IN THE MATTER OF AN APPLICATION TO  
AN BORD PLEANÁLA

FOR APPROVAL OF (I) THE N6 GALWAY CITY RING ROAD  
PURSUANT TO SECTION 51 OF THE ROADS ACT 1993 (AS  
AMENDED); (II) THE N6 GALWAY CITY RING ROAD  
MOTORWAY SCHEME 2018; and (III) THE N6 GALWAY CITY  
RING ROAD PROTECTED ROAD SCHEME 2018

STATEMENT OF EVIDENCE

Responses to Engineering, Need for the Project,  
Alternatives Considered and Material Assets Non-  
Agriculture

**Figure 1: Alternatives routes considered**

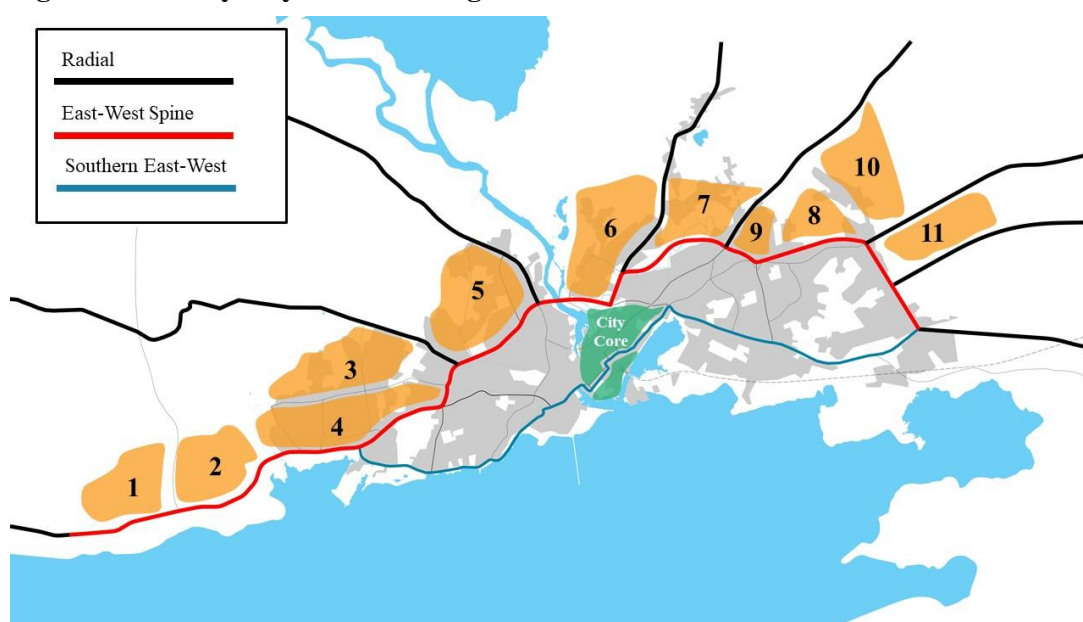
- Why not 2006 Galway City Outer Bypass Route?: Ob\_108\_125, Ob\_111, Ob\_116, Ob\_117, Ob\_123, Ob\_141, Ob\_152, Ob\_155, Ob\_158, Ob\_201, Ob\_204, Ob\_239, Ob\_241\_245, Ob\_243, Ob\_312, Ob\_510, Ob\_519, Ob\_531.02, Ob\_584, Ob\_610, Ob\_611, Ob\_621, Ob\_636\_637, Ob\_642, Ob\_708\_709, S\_022, S\_037 and S\_055
- Route selection in Bearna and the western city suburbs: Ob\_201, Ob\_241\_245, Ob\_243 and Ob\_312
- Route selection from River Corrib east to Castlegar: Ob\_584, Ob\_569, Ob\_610, Ob\_612, Ob\_621, Ob\_636\_637 and Ob\_642
- Route selection in the Ballybrit and Briarhill area: Ob\_691, Ob\_O\_761.3, and Ob\_724
- Route selection of the N59 Link Road South: S\_011, S\_029, S\_044, S\_051, S\_056, S\_057, S\_060, Ob\_486 and S\_065

4.3.3 Detailed environmental studies were undertaken on the entire study area so that a comprehensive multi-criteria assessment of the various options, shown on Figure 1 below, could be completed. Figure 1 shows the routes assessed in Section 4.7.2 of Chapter 4 of the EIAR all on one figure for ease of comparison. Included in this environmental assessment and criteria is an assessment of the impact on people, homes and communities. Whilst every effort was made to avoid homes, the avoidance of all properties is unfortunately not possible given the linear development of the city with housing along every road radiating out of the city.

**Figure 5: Pedestrian Access to Rosán Glas from Ragoon Road**

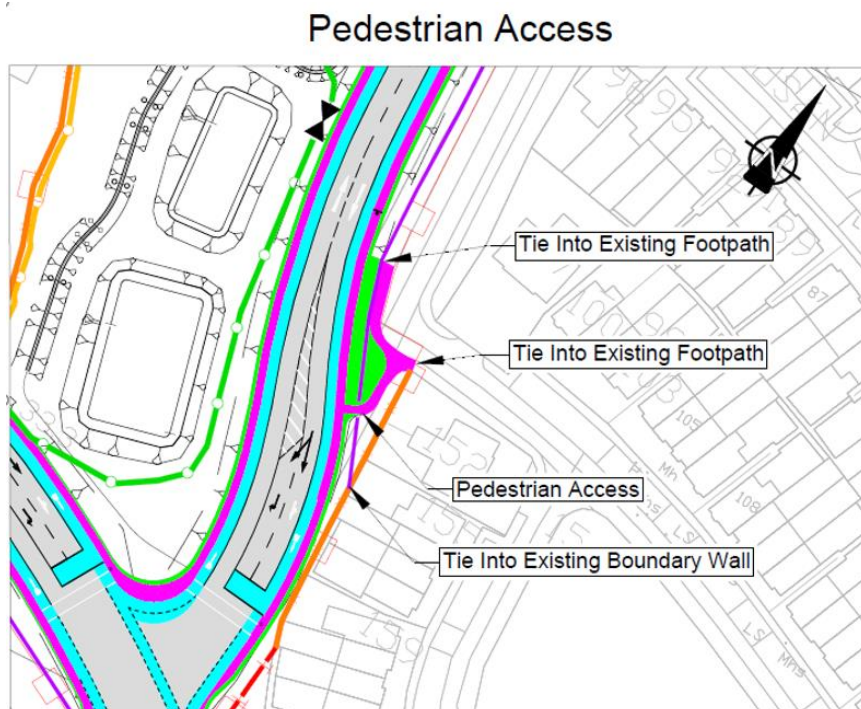
- 4.6.22 Many of the submissions are concerned that the estate which is currently on a cul-de-sac will be located adjacent to a key road such as the N59 Link Road South. A 1.2m high boundary wall is proposed on the western boundary of Bóthar Diarmuida to maintain the separation between it and the N59 Link Road as shown on Figure 1.6.25 of Appendix A.1.9 of the RFI Response. This will restore the sense of privacy of the estate.

- 4.6.21 A pedestrian connection from the internal Rosán Glas estate road network to the Ragoon Road will be provided at the existing Ragoon Junction location so that the desire line for pedestrians is not affected by the relocation of the residential area entrances. This is shown on Figure 5 below together with the vehicular access arrangements to the residential area as shown on Figure 1.10.11 of Appendix A.1.13 of the RFI Response. S\_029 seeks to retain the existing planting in this existing entrance area, and this is protected during construction by the provision of a temporary fence around it as shown on Figure 1.6.26 of Appendix A.1.9 of the RFI Response.

**Figure 6: N59 Letteragh Junction Traffic Dispersion**

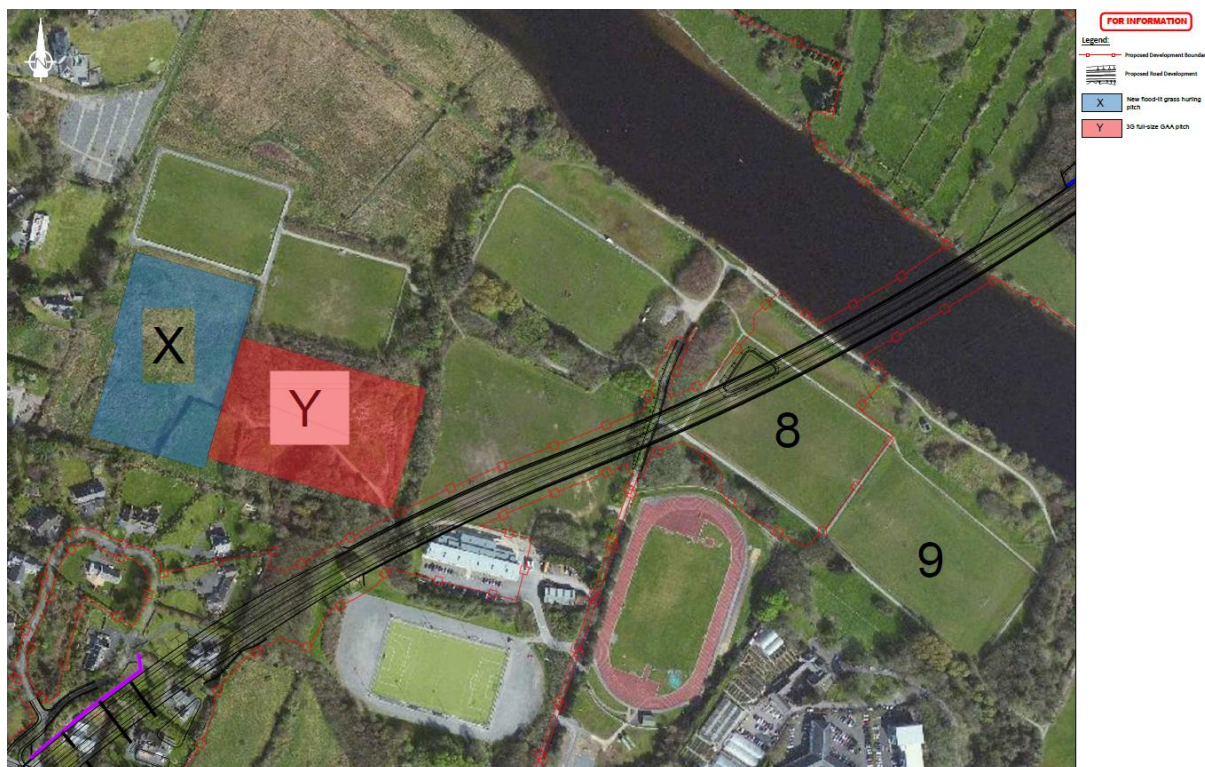
- 4.6.28 Ob\_510, Ob\_511.05, Ob\_511.06, Ob\_511.07, Ob\_511.16, Ob\_511.25, Ob\_511.18, Ob\_512.1, S\_020, S\_070: The residents in The Heath object to the provision of AR 07/10 which connects to the internal estate road. They argue that the internal estate road is *‘in no way suitable for agricultural traffic’*, *‘was designed only for light traffic loading for a small number of dwellings’*. AR 07/10 is a private access road to give access to lands severed by the N6 GCRR in plot 506 as noted in Table 9.3 of Section 9.4 of the RFI Response. Plot 506 is currently zoned agricultural, with the severed portion totalling 1.14 hectare. However, the existing internal estate road serves existing plot 504 in its entirety, total area 3.09 hectares, and the western part of plot 510, total area 0.41 hectares, both of which are zoned agricultural land. As the portion of additional agricultural lands which will be accessed via this internal estate road is only 1.14 hectares, the internal estate road will have the capacity to cater for it. It is considered that the internal estate road is the correct access point for this severed land as it is immediately adjacent to it as opposed to rerouting it via the neighbouring serviced roadway to the south.

- 4.6.34 As can be seen, the slip ramps direct traffic to a new link road, N59 Link Road, which has been designed to standard to receive this traffic. There is no connection to Circular Road as intimated in Ob\_510.

**Figure 8: Photo of site notice**

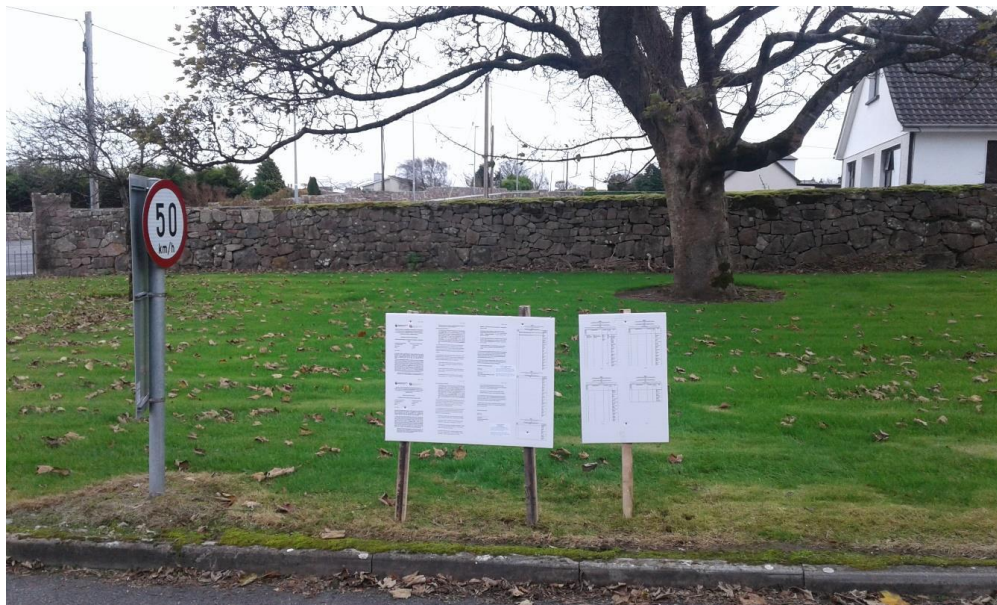
- 4.17.10 Ob\_569 raise concerns that the server map and the schedule issued to them are incorrect.
- 4.17.11 Ob\_584 claims the N6 Galway City Ring Road Protected Road and Motorway Schemes is rendered invalid as she was only given 1 weeks' notice of same.

- 4.17.26 Ob\_511.06 & 511.25: The property owners on both objections were included as occupiers on plot 511, the internal estate road at The Heath, at the time of publication, at their addresses as per their current folio. The registered notices were returned in the post. A public notice was erected at the front of the estate for the duration of the public display with the appropriate schedules attached as shown on the photo inserted below (Figure 8) with the property owners listed. The schedules and server maps relating to these property owners have been amended to also include their addresses in The Heath, and Notice to this effect with amended schedule extracts from Schedule 1 Part 2 and Schedule 3 Part 2 of the N6 GCRR Motorway Scheme and updated server maps were issued to the property owners.
